Number: V2500-NAC-71-0282

SUBJECT: NOSE COWL - FORWARD AND REAR BULKHEAD FITTINGS, THERMAL ANTI-ICE DUCT , NOSE COWL - MODIFICATION OF

"MODIFICATION SERVICE BULLETIN" - "NACELLE - EXHAUST - FORWARD AND REAR
BULKHEAD FITTINGS, THERMAL ANTI-ICE DUCT, NOSE COWL - MODIFICATION
OF"

Nose Cowl T.A.I. Installation Modification
Figure 1 (sheet 1)

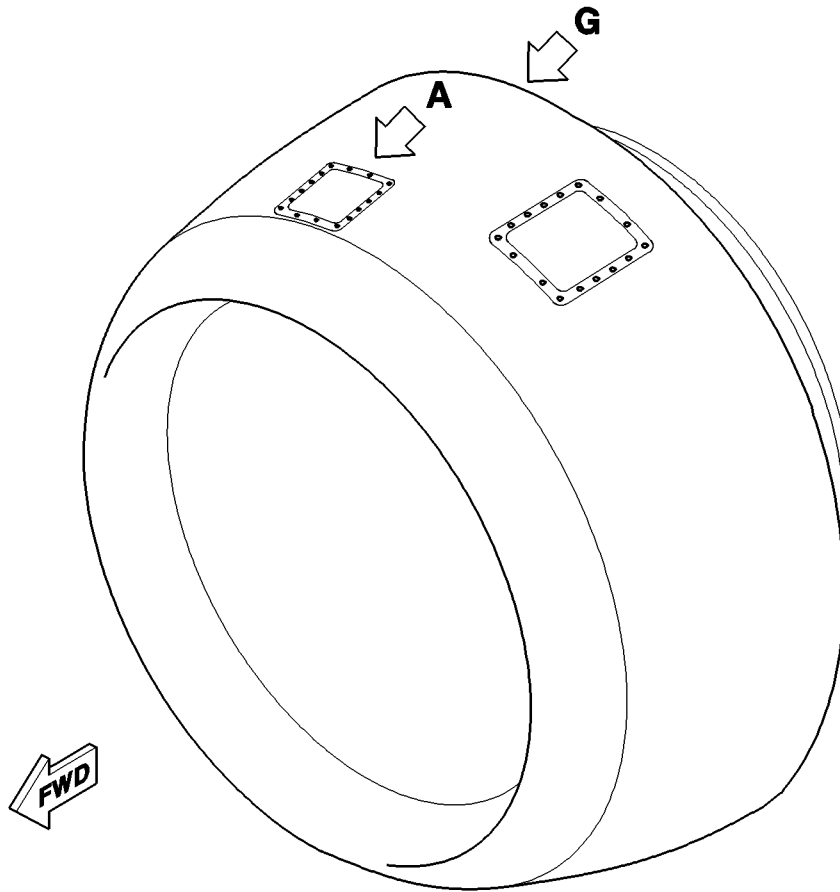
A. Remove the T.A.I. duct and the inner and outer rear bulkhead duct assemblies. Refer to Figure 1.

B. Remove the 290-3395-505 or 290-3004-1AE forward bulkhead fitting. Refer to Figure 1.

Nose Cowl T.A.I. Installation Modification
Figure 1 (sheet 2)

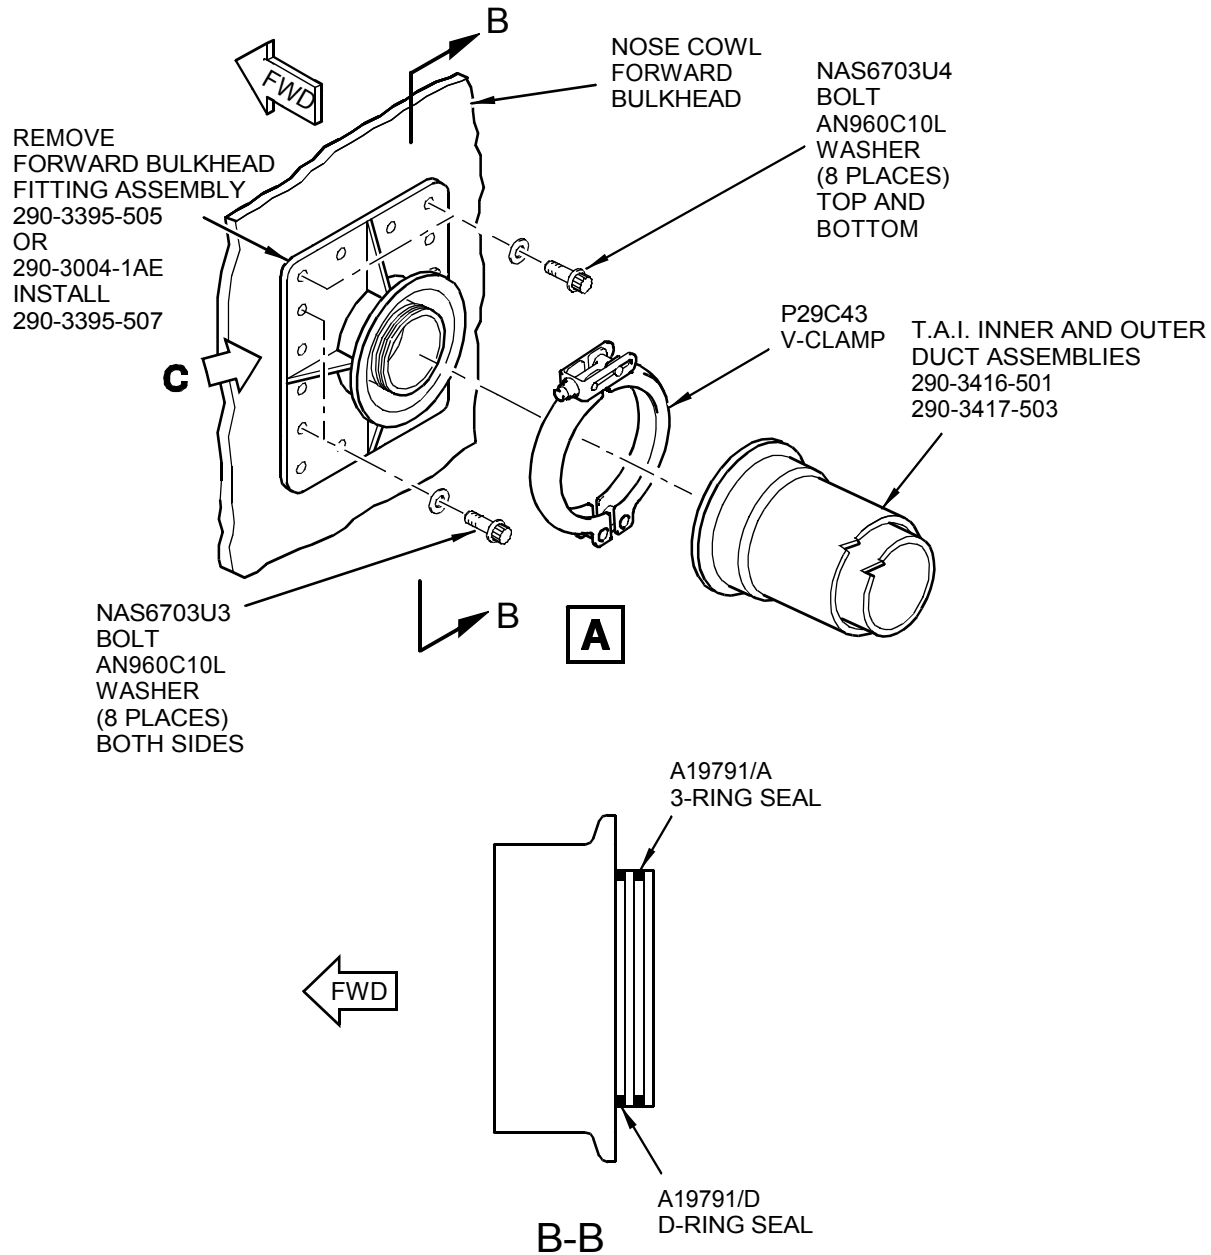
- (2) Install one each of the 2.75 inch (69,85 mm) diameter A1971/D d-ring seals in the forward recess and one 2.75 inch (69,85 mm) diameter A19791/A 3-ring seal in the aft recess of the forward bulkhead fitting. Make sure the gaps on the 3-ring seals are rotated 120 degrees from each other. Refer to Figure 1 (sheet 2).

- G. Install the T.A.I. duct, the 290-3398-507 inner rear bulkhead fitting, and the 290-3394-503 outer rear bulkhead duct assembly.
- (1) Install the 290-3416-501 inner duct and then the 290-3417-503 outer duct on the 290-3395-507 fitting at the forward bulkhead. Make sure the seals remain in the proper position on the fitting when you install the ducts. Refer to Figure 1 (sheet 2).

- (2) Loosely install the P29C43 V-clamp on the forward end of the 290-3417-503 duct and flange of the 290-3395-507 fitting at the forward bulkhead. Position the tightening feature of the clamp so it is accessible from the access panel opening. Refer to Figure 1 (sheet 2).

- (10) Tighten the P29C43 V-clamp at the forward bulkhead. Torque the set screw to 35-40 in-lbs (3,95-4,52 Nm). Refer to Figure 1 (sheet 2).

Nose Cowl T.A.I. Installation Modification
Figure 1 (sheet 3)

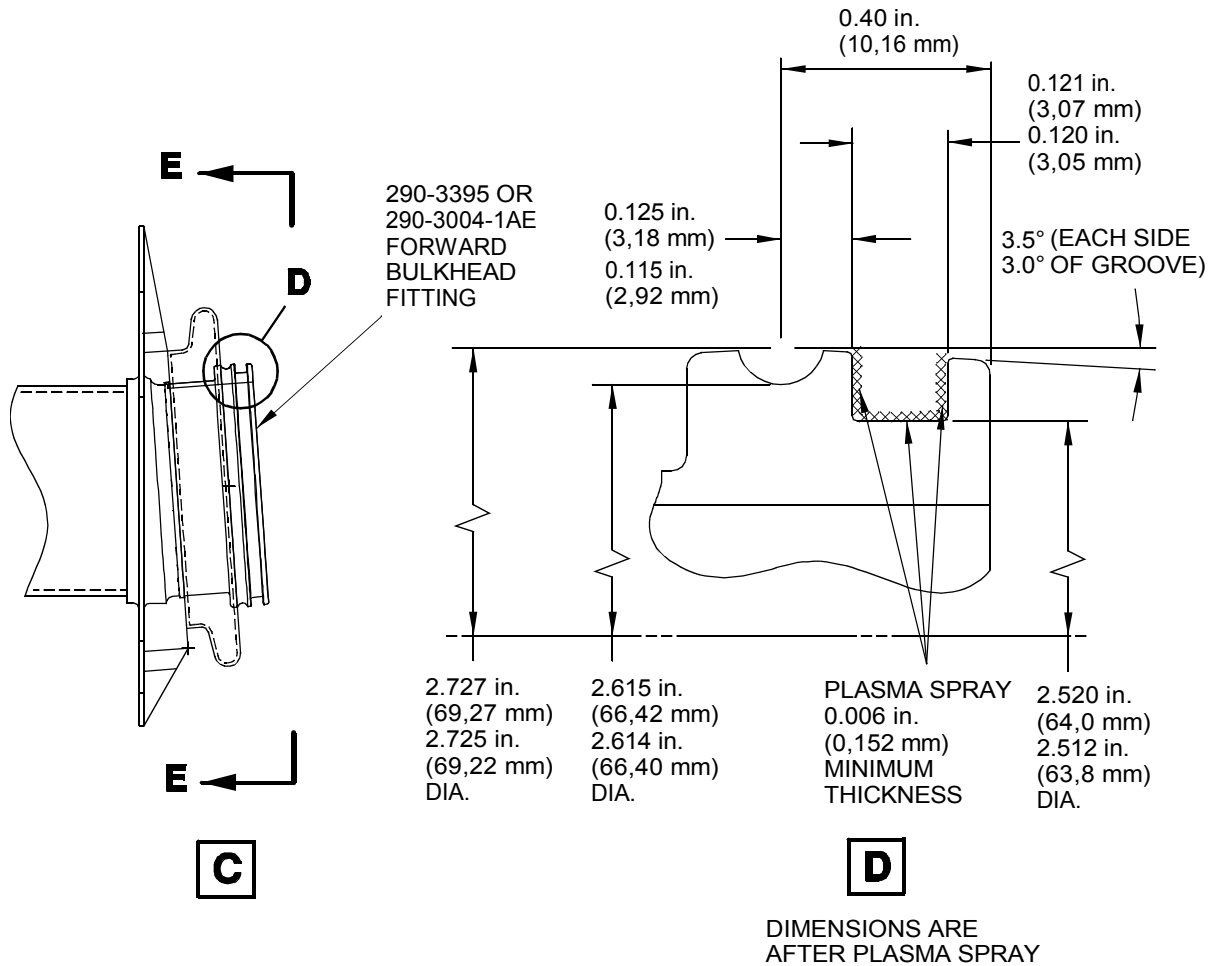
(1) Apply plasma spray coating (CoMat 03-065)(tungsten carbide/cobalt) to the 290-3395-505 or 290-3004-1AE fitting. Refer to the Standard Practices/Processes Manual (SPP-V2500-1IA), Chapter 70-34-03. Maintain minimum coating thickness of 0.006 inch (0,152 mm) and surface finish of 125RA after machining to final dimensions. Refer to Figure 1 (sheet 3).

NOTE: It may be necessary to remove material from the fitting before you apply the plasma spray coating so that the minimum thickness of the coating is 0.006 inch (0,152 mm) after machining to final dimensions shown in Figure 1 (sheet 3).

Nose Cowl T.A.I. Installation Modification
Figure 1 (sheet 4)

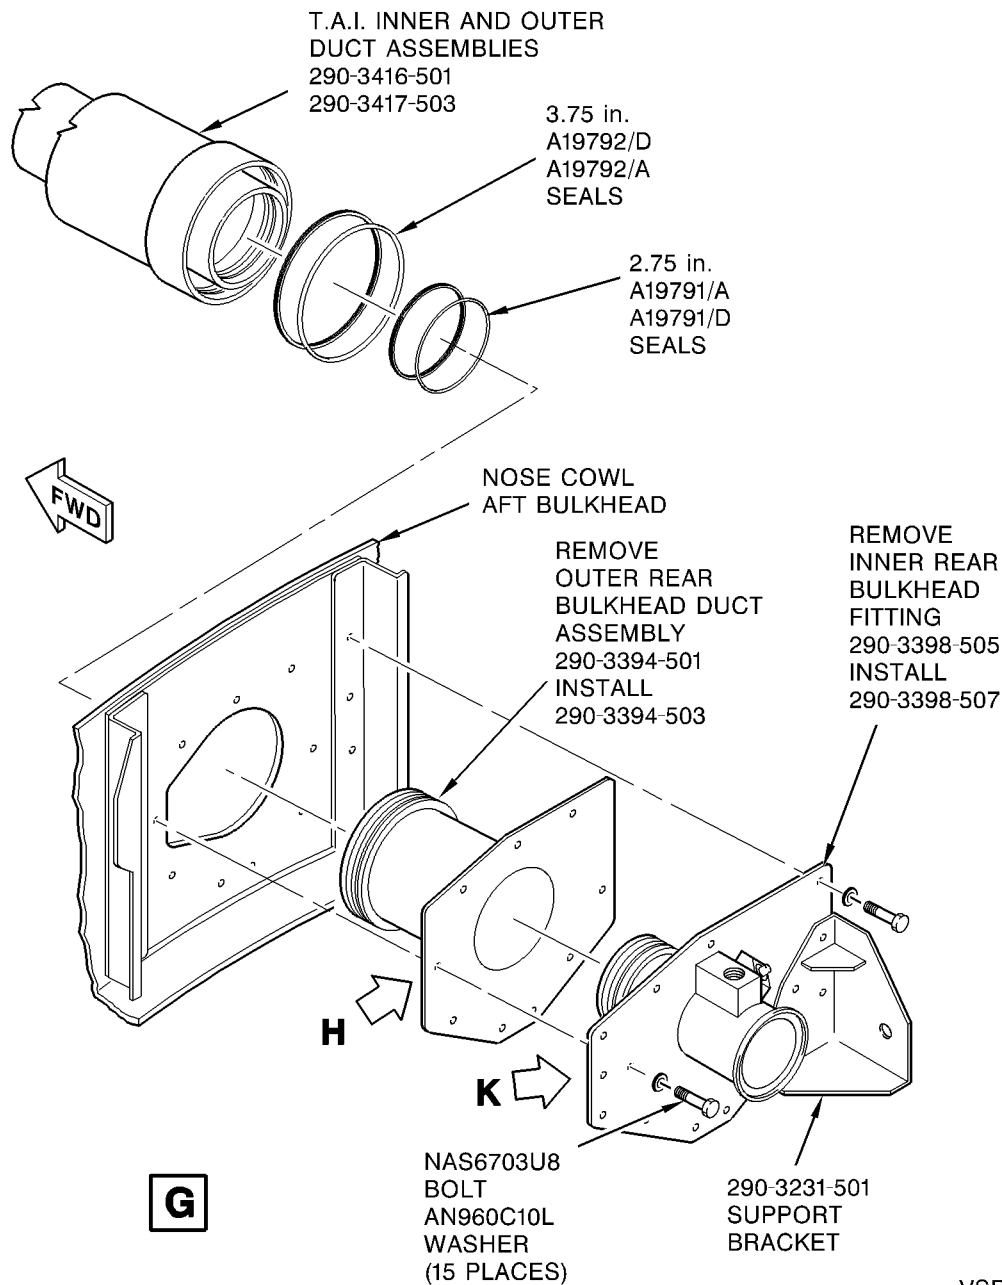
- (6) Put the 290-3394-503 outer rear bulkhead duct assembly on the aft end of the 290-3417-503 duct. Put the 290-3398-507 inner rear bulkhead fitting on the 290-3416-501 duct. Make sure the attach holes of the two fittings align. Refer to Figure 1 (sheet 4).

- (9) Attach the outer rear bulkhead assembly and inner rear bulkhead assembly to the aft bulkhead with fifteen NAS6703U8 bolts and AN960C10L washers. Torque the bolts to 40 in-lbs (4,52 Nm). Refer to Figure 1 (sheet 4).

Nose Cowl T.A.I. Installation Modification
Figure 1 (sheet 5)

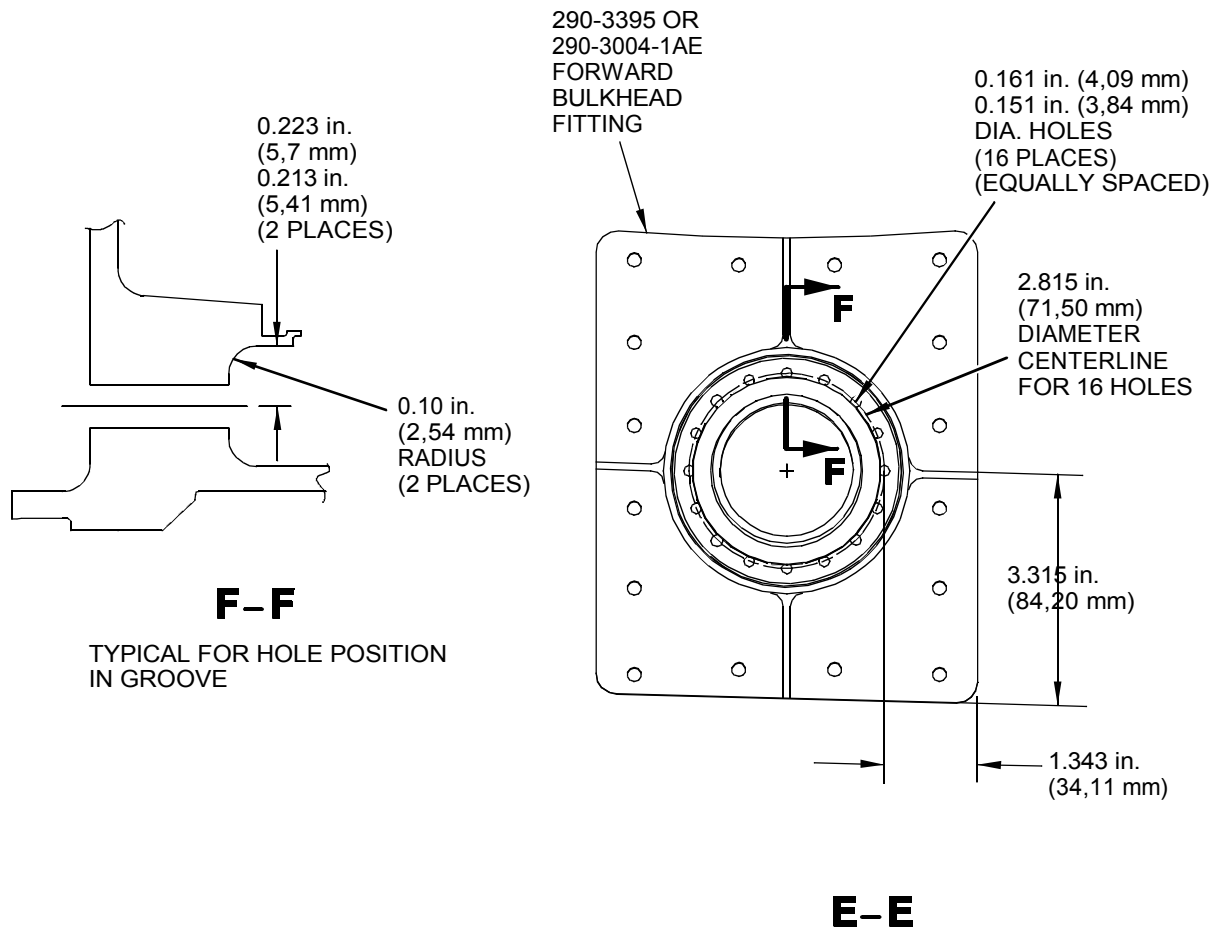
(2) Drill 16 holes through the 290-3395-505 or 290-3004-1AE forward bulkhead fitting. Refer to Figure 1 (sheet 5).

Nose Cowl T.A.I. Installation Modification
Figure 1 (sheet 6)

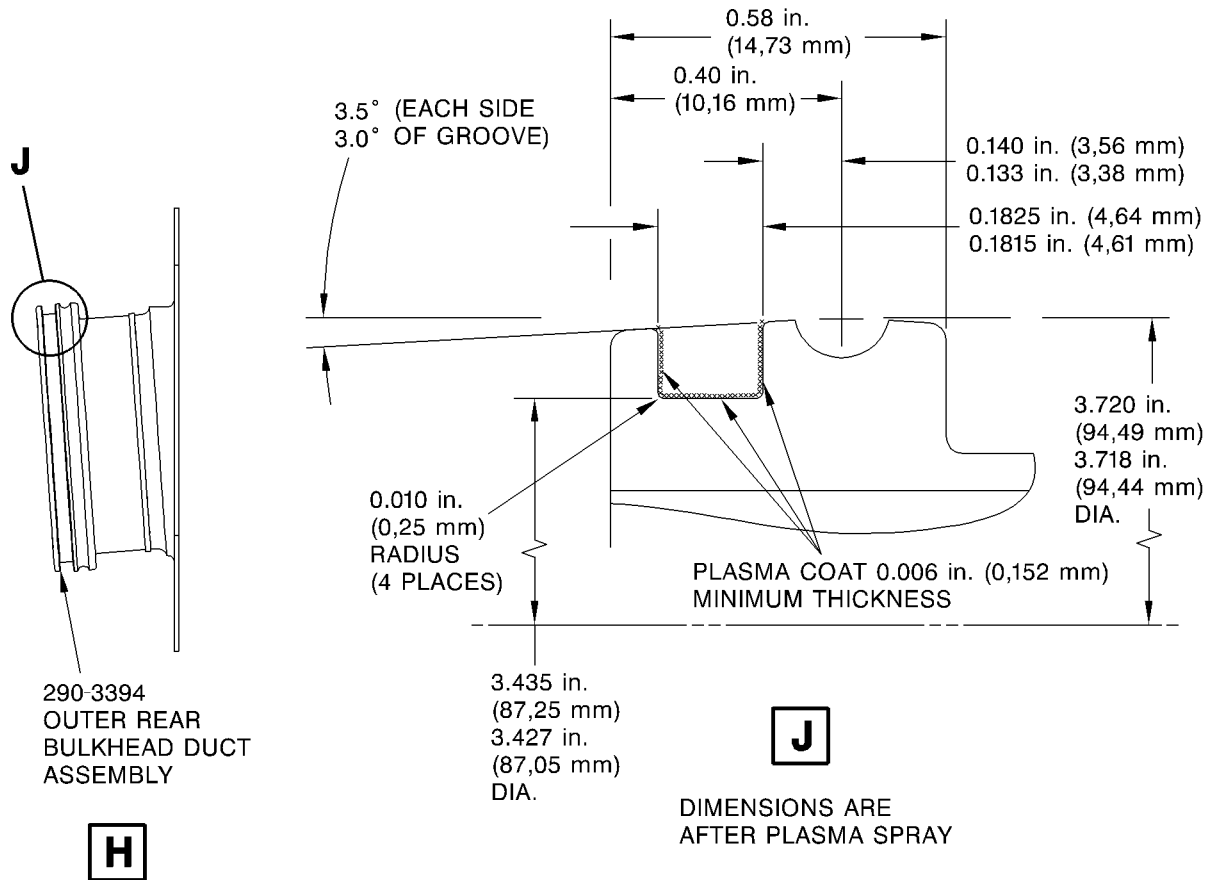
- (1) Apply plasma spray coating (CoMat 03-065)(tungsten carbide/cobalt) to the 290-3394-501 assembly. Refer to the Standard Practices/Processes Manual (SPP-V2500-1IA), Chapter 70-34-03. Maintain minimum coating thickness of 0.006 inch (0,152 mm) and surface finish of 125RA after machining to final dimensions. Refer to Figure 1 (sheet 6).

NOTE: It may be necessary to remove material from the assembly before you apply the plasma spray coating so that the minimum thickness of the coating is 0.006 inch (0,152 mm) after machining to final dimensions shown in Figure 1 (sheet 6).

- (3) Install the 3.75 inch (95,25 mm) diameter A19792/D d-ring seal (aft most recess on the 290-3394-503 outer rear bulkhead duct assembly) and the 3.75 inch (95,25 mm) diameter A19792/A 3-ring seals (forward most recess on the outer rear bulkhead duct assembly). Make sure the gaps on the 3-ring seals are rotated 120 degrees from each other. Refer to Figure 1 (sheet 6).

Nose Cowl T.A.I. Installation Modification
Figure 1 (sheet 7)

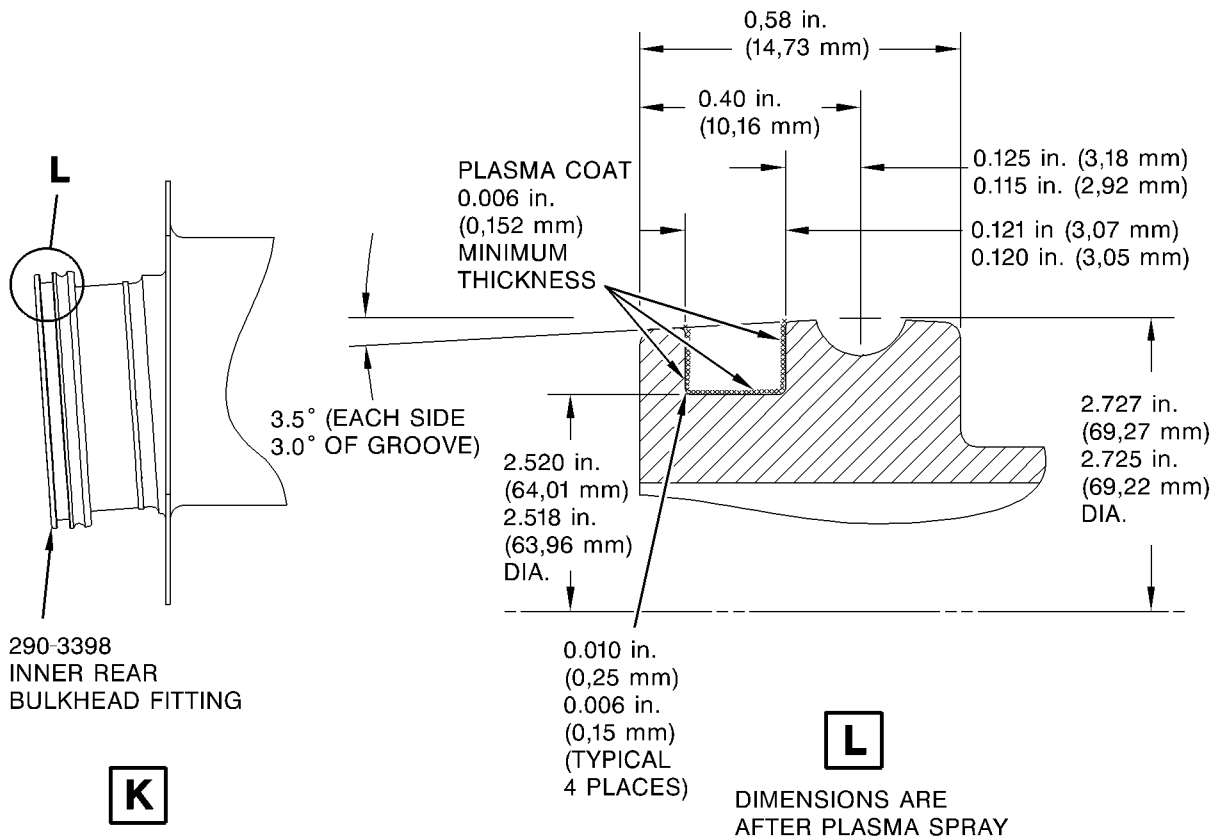
- (1) Apply plasma spray coating (CoMat 03-065)(tungsten carbide/cobalt) to the 290-3398-505 fitting. Refer to the Standard Practices/Processes Manual (SPP-V2500-1IA), Chapter 70-34-03. Maintain minimum coating thickness of 0.006 inch (0,152 mm) and surface finish of 125RA after machining to final dimensions. Refer to Figure 1 (sheet 7).

NOTE: It may be necessary to remove material from the fitting before you apply the plasma spray coating so that the minimum thickness of the coating is 0.006 inch (0,152 mm) after machining to final dimensions shown in Figure 1 (sheet 7).

- (4) Install the 2.75 inch (69,85 mm) diameter A19791/D d-ring seal (aft most recess on the 290-290-3398-507 inner rear bulkhead fitting) and the 2.75 inch (69,85 mm) diameter A19791/A 3-ring seals (forward most recess on the inner rear bulkhead fitting). Make sure the gaps on the 3-ring seals are rotated 120 degrees from each other. Refer to Figure 1 (sheet 7).
